# Service Bulletin

NO. 325

## Studebaker and Packard Clipper

Fig. 1

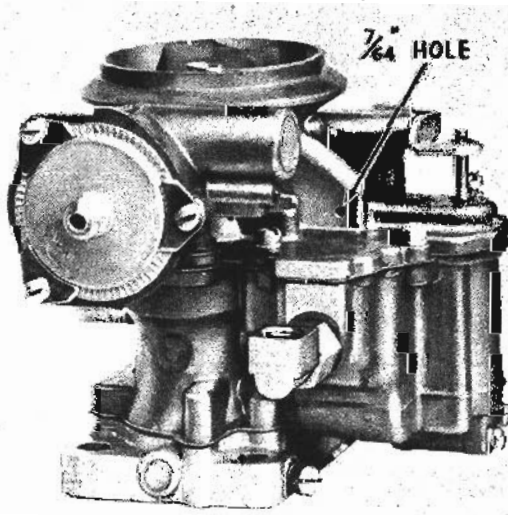
1. Remove the carburetor air chamber cover and remove the carburetor from the engine.
2. Drill a  $7/64$ " hole into the vent passage at the location shown in Fig. 1. Then, drill two  $5/64$ " holes in the throttle body at the locations shown in Fig. 2. It is not necessary to disassemble the carburetor to drill the holes but care should be taken to prevent chips from entering the carburetor.
3. If the air chamber cover does not have a

Fig. 3

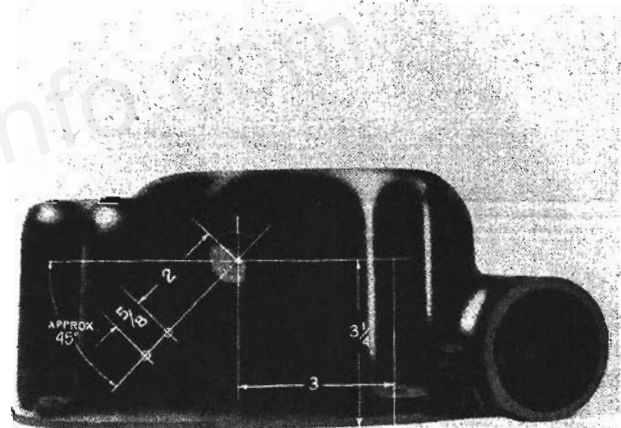
vent valve (flapper valve) locate and drill a 1" hole and two  $5/32$ " holes in the air chamber cover at the locations shown in Fig. 3. Install the Air Chamber Vent Valve Assembly, Part No. 1542765 in the cover (see Fig. 4), placing two small flat washers be-

Fig. 4

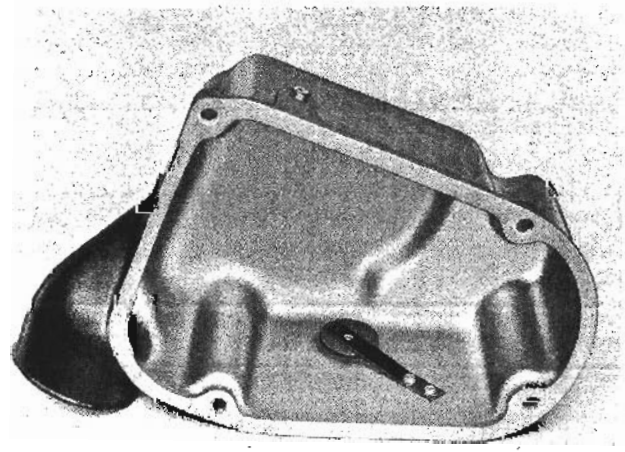
tween the spring and the cover and using two self-tapping screws, Part No. G453113. After the valve is installed, bend the spring as required to obtain an opening of 1/4" between the cover and the highest point at the outer edge of the valve.

Fig. 5

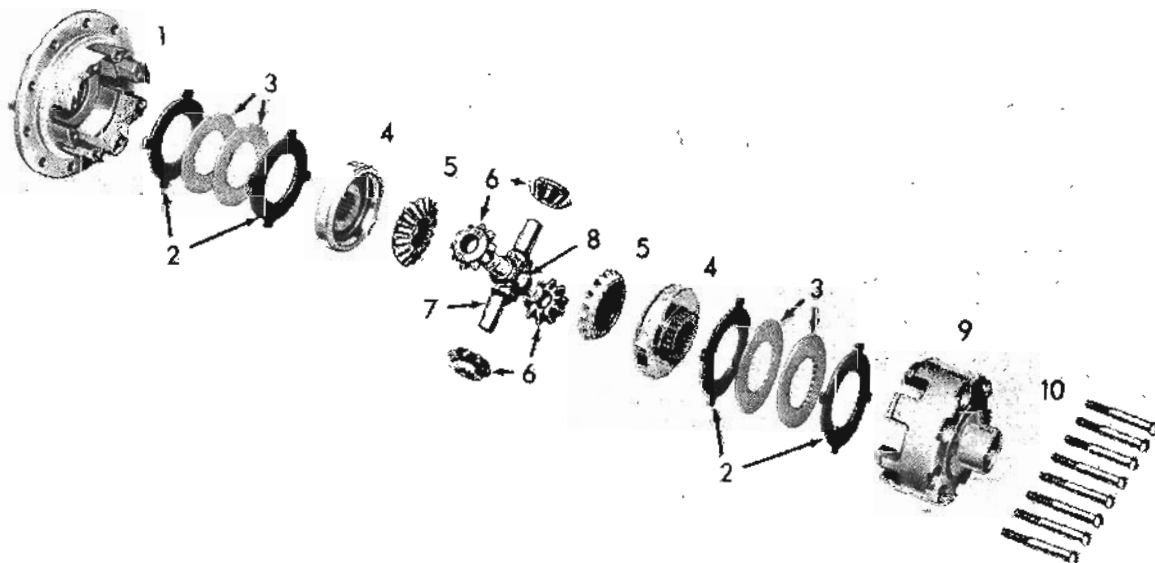
A change has been made in the Twin-Traction differential; the cone-type clutches have been replaced by disc-type clutches. Fig. 5 illustrates the exploded view of the latest type.

The disassembly and reassembly procedure with the exception of the clutches is the same for both types. When reassembling the disc type, the lugs of the plates are placed in the notches provided in the housing. Note the relationship of the discs to the plates; the two friction discs are placed between the plates.

Fig. 7

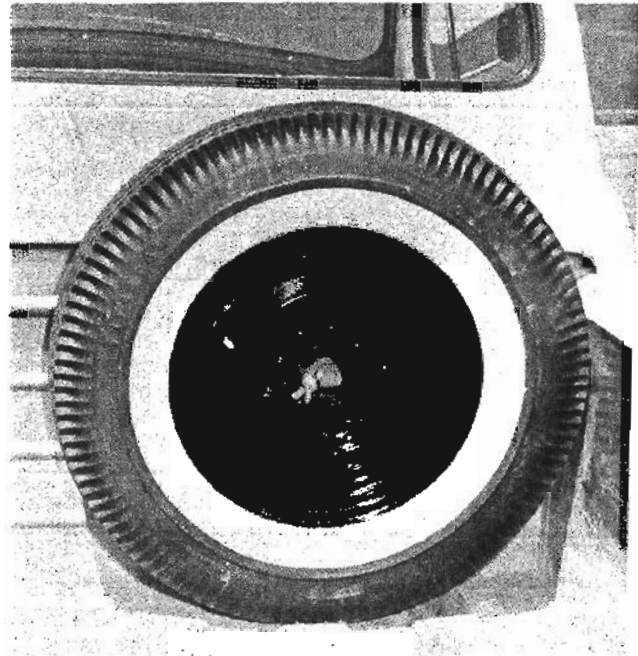
Recently a new location for the spare tire was released as a factory installed option for trucks equipped with a pickup body. At the optional location, the tire is mounted at the front wall of the body (see Fig. 7). This can very readily be adapted to prior models for owners desiring this "in the box" location.

Fig. 8

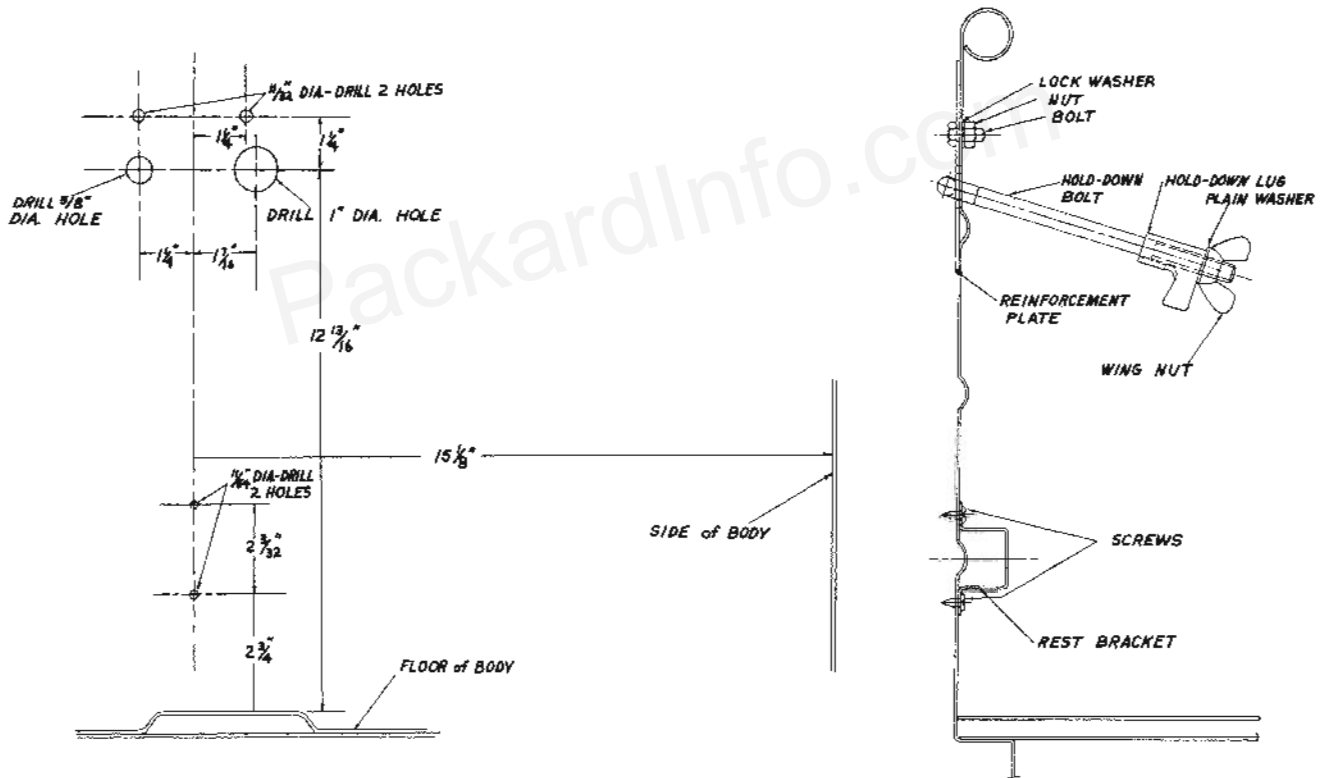
Drill the front wall of the pickup body at the locations indicated in Fig. 8. Install the reinforcement plate and install the hold-down bolt in the lower set of holes. Drill two holes for the rest bracket retaining screws at the locations shown in Fig. 8 and install the bracket.
